project: BRUNSWICK MILL DEVELOPMENT PHASE 1
scale: 1:200 @A1
drawn by: TC

title: LEVEL 6 PROPOSED
drawing number: L(20)206

status: STAGE 5 – CONSTRUCTION
job number: 0586
revision: C5

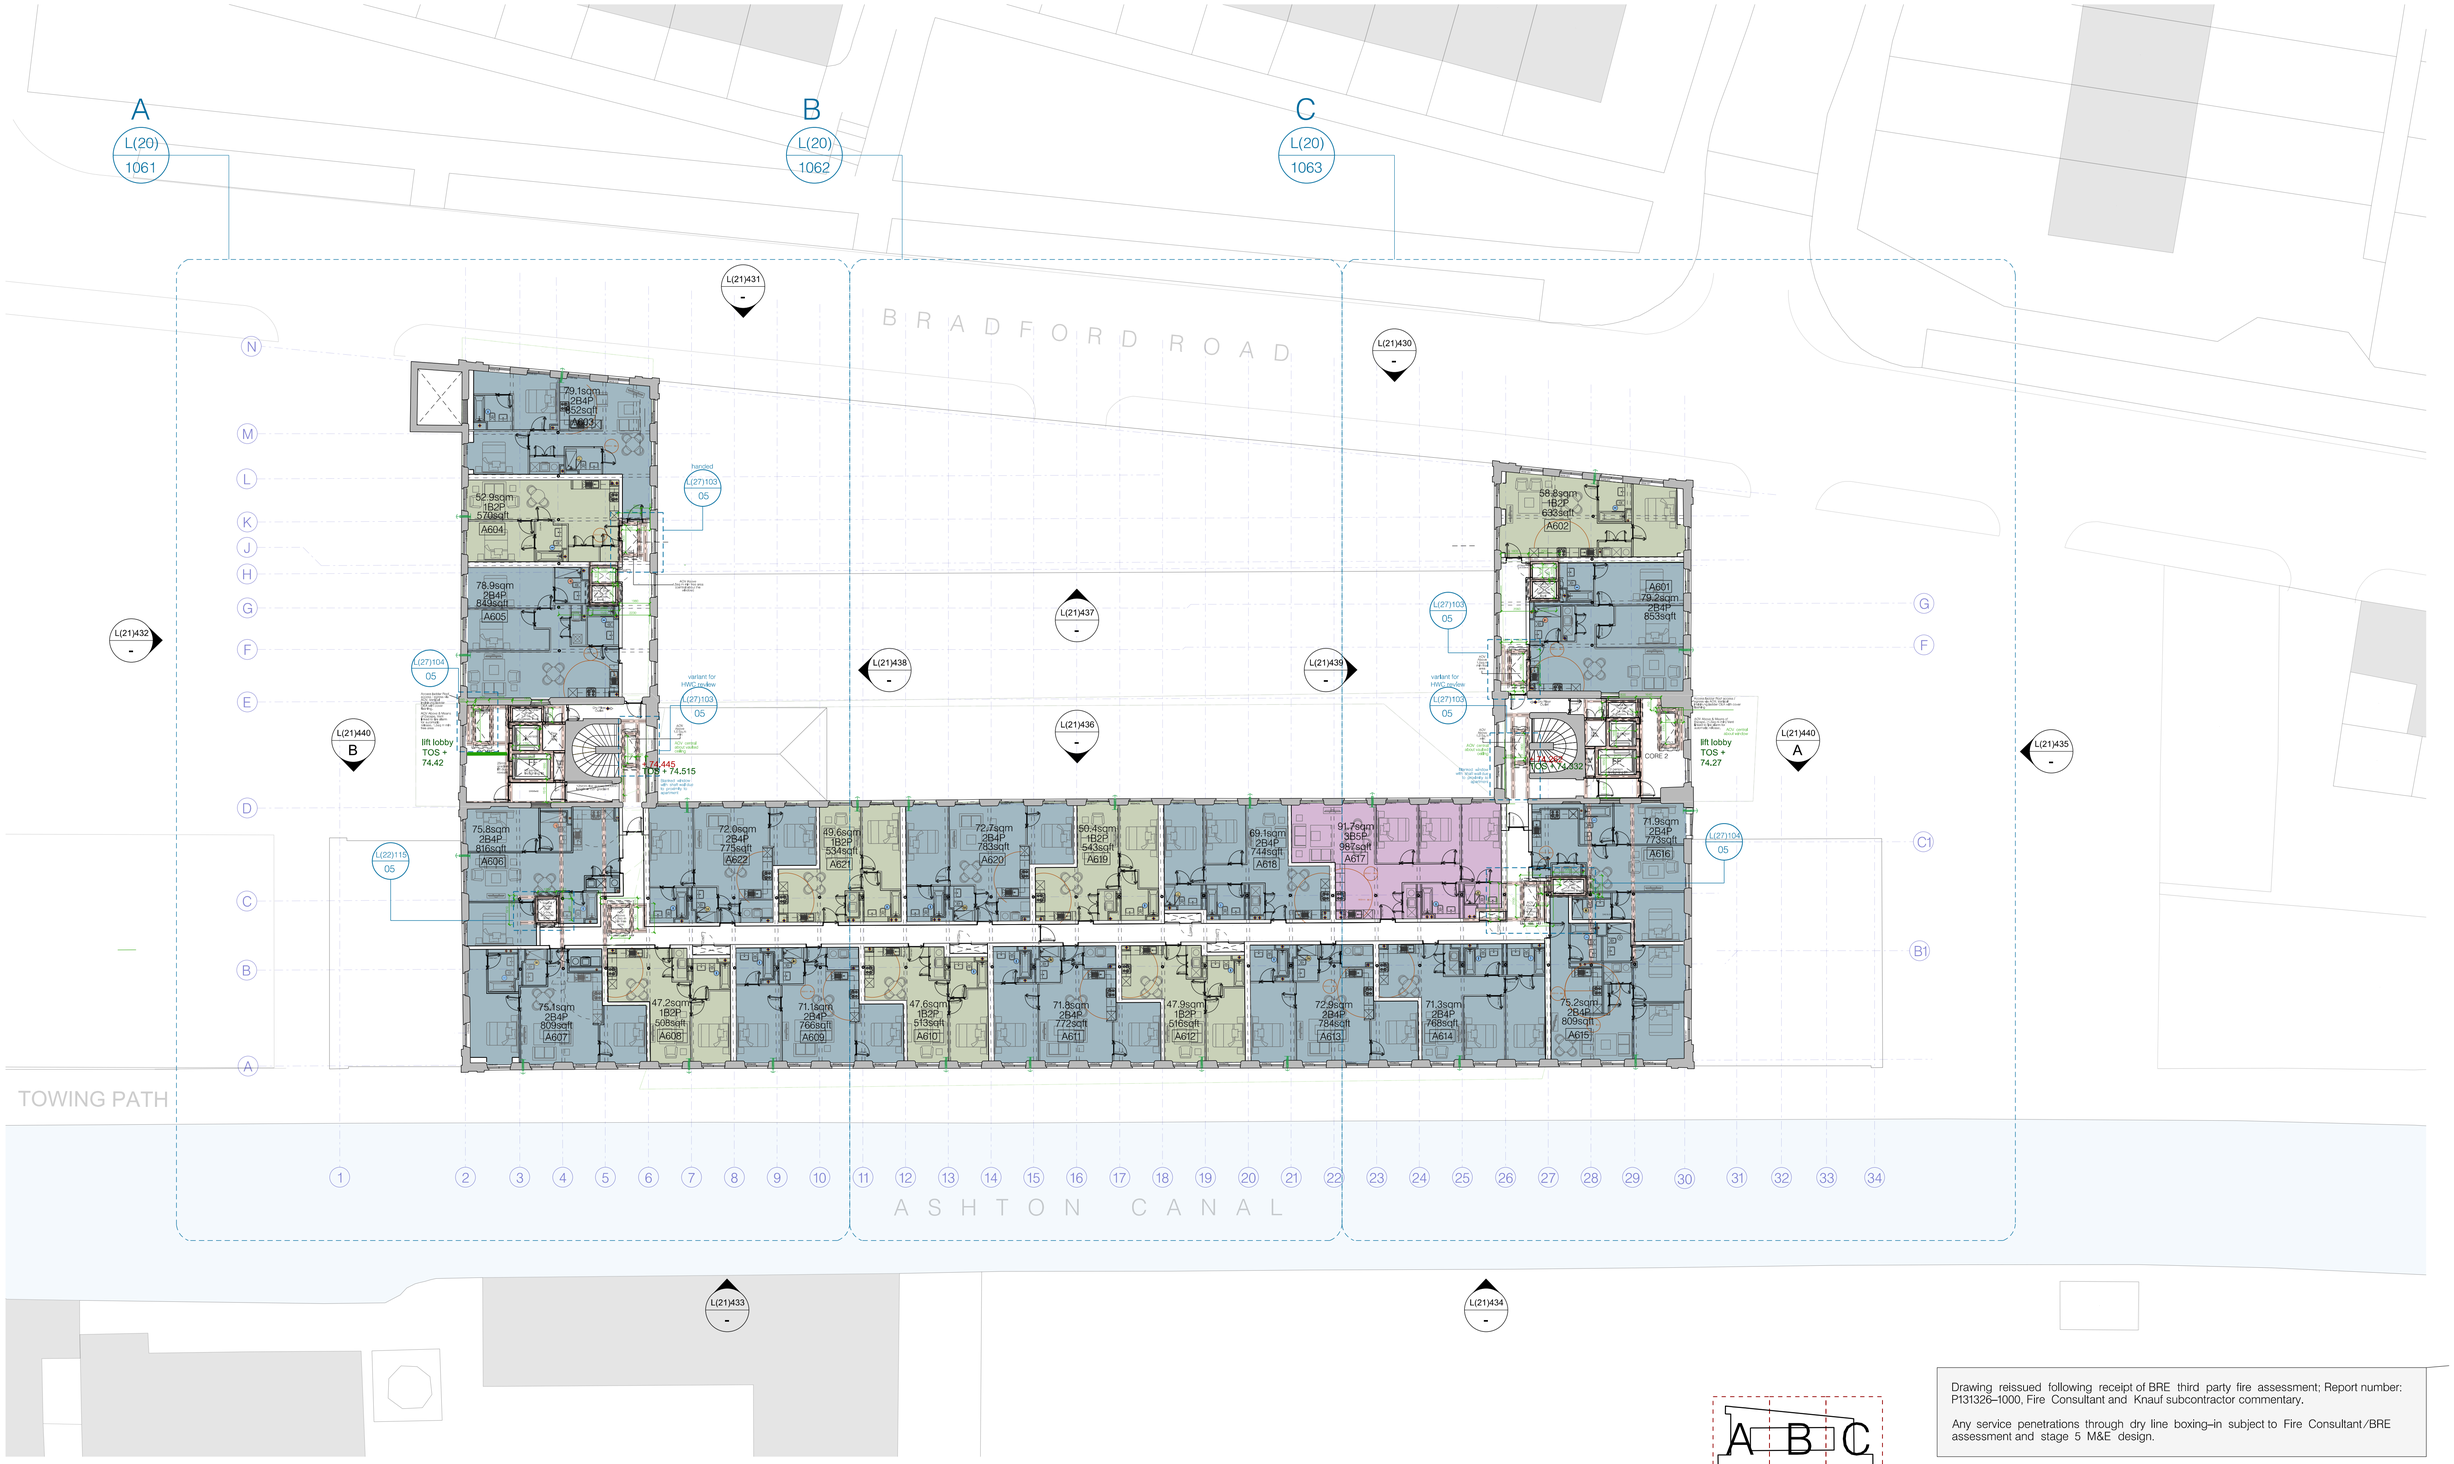
Drawing reissued following receipt of BRE third party fire assessment; Report number: P131326–1000, Fire Consultant and Knauf subcontractor commentary.

C5	04.12.25	WALL AND DOOR SETTING OUT TO ALLOW FOR SVP AND DRY LINING POST BRE REPORTING, MINOR SMOKE AND SERVICE CORE UPDATE FURTHER TO STRUCTURAL COORDINATION. MEV POSITION UPDATE

CONSOLUX TO REVIEW ALL SVP SET OUT - SPACE BEHIND SHOWER SPACE. SPACING INBETWEEN SVPS FOR STRUCTURAL CORING. & N/E UNIT KITCHEN CHANGE. CONSOLUX TO UPDATE DWGS TO ALLOW FOR REFERENCE INTO ARCHITECTURAL DWGS
